Test Report No: 07CA54500-FCC
Date of Issue: November 12, 2007

INTERNAL PHOTOS

EUT Modification

EUT Modification for Radiation Disturbance

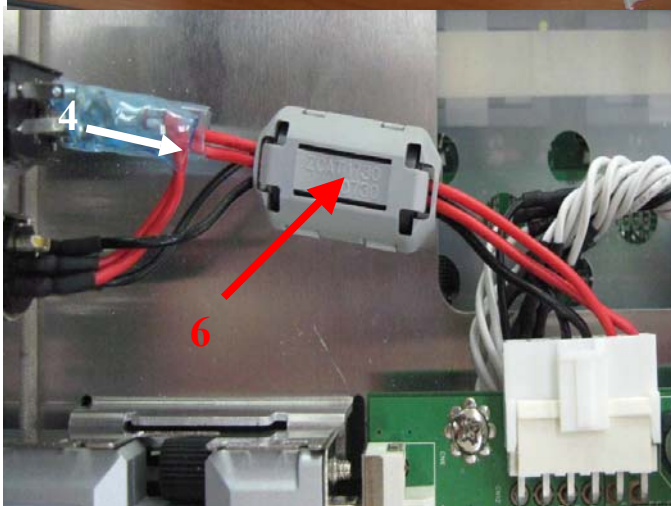
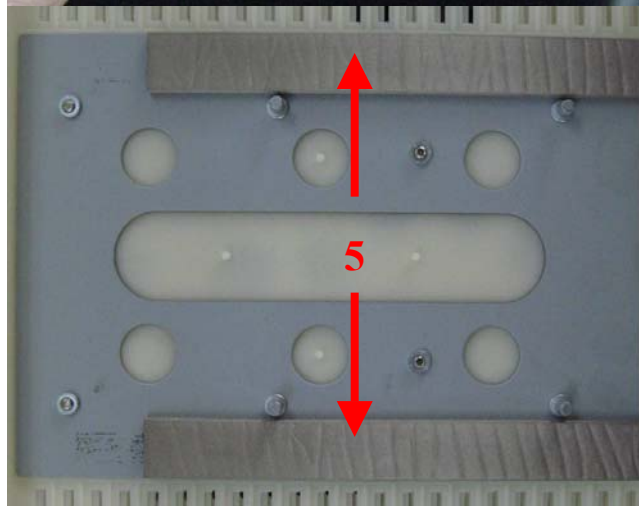
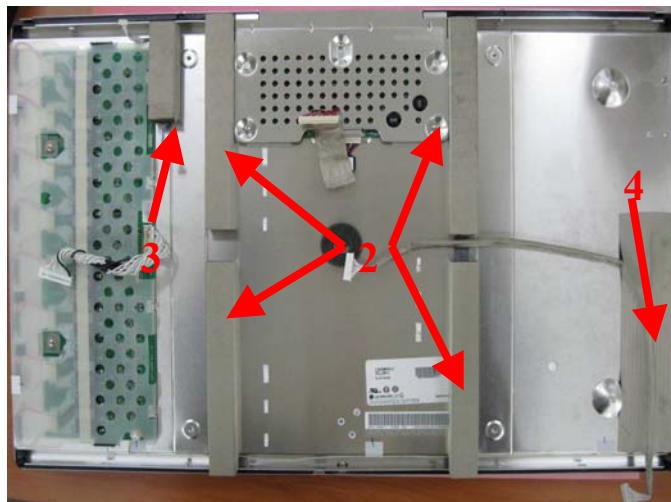
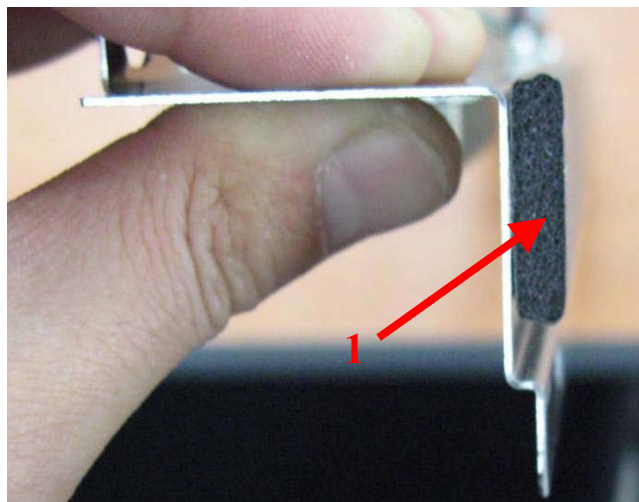
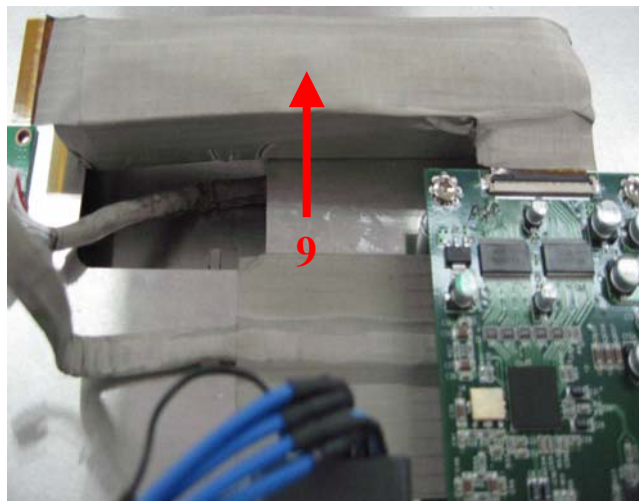
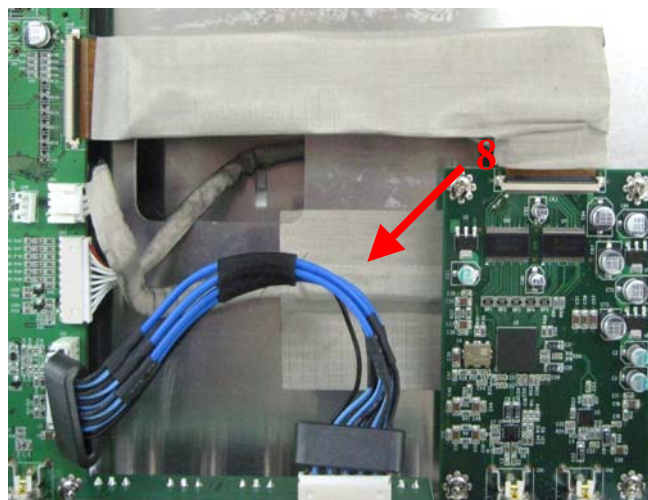
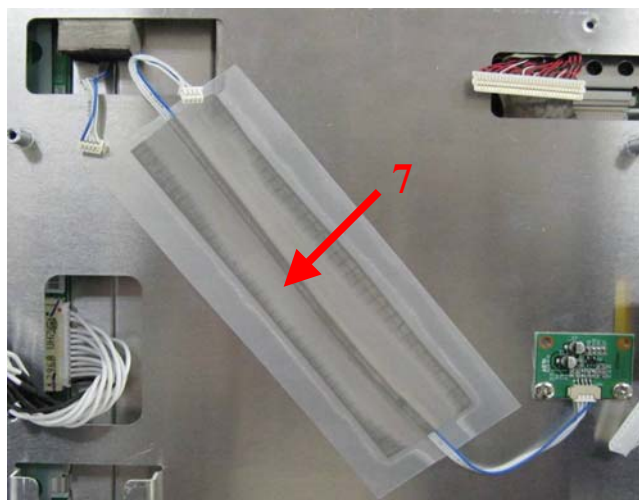
#1	Attach the EMI form gasket (20x4x490mm) under the Connector bracket to make strong ground contact with mainframe.
#2	Attach the EMI form gasket (22x20x170mm) at these 4 points to make more strong ground contact with LCD panel and mainframe.

#3	Attach the EMI form gasket (22x20x80mm) with the temperature sensor cable.
#4	Adhere the EMI tape like this picture with the OSD cable.
#5	Attach the EMI form gasket (20x5x175) at this 2 point on the VESA mount bracket to enhance shield case and rear cover contact

#6	Insert the clamp ring style ferrite core (TDK, type: ZCAT1730-0730A) through the DC input cable.
#7	Adhere the EMI tape like this picture with the light sensor cable.

#8	Insert the flat ring style ferrite core (SCC Co.,Ltd, type : PC2910) on the both side of component(YPbPr) cable.
#9	Attach the EMI form gasket (27x15x140mm) at this point and contact with FPC Cable by using EMI tape to reduce the amount of radiation occurring from FPC cable.
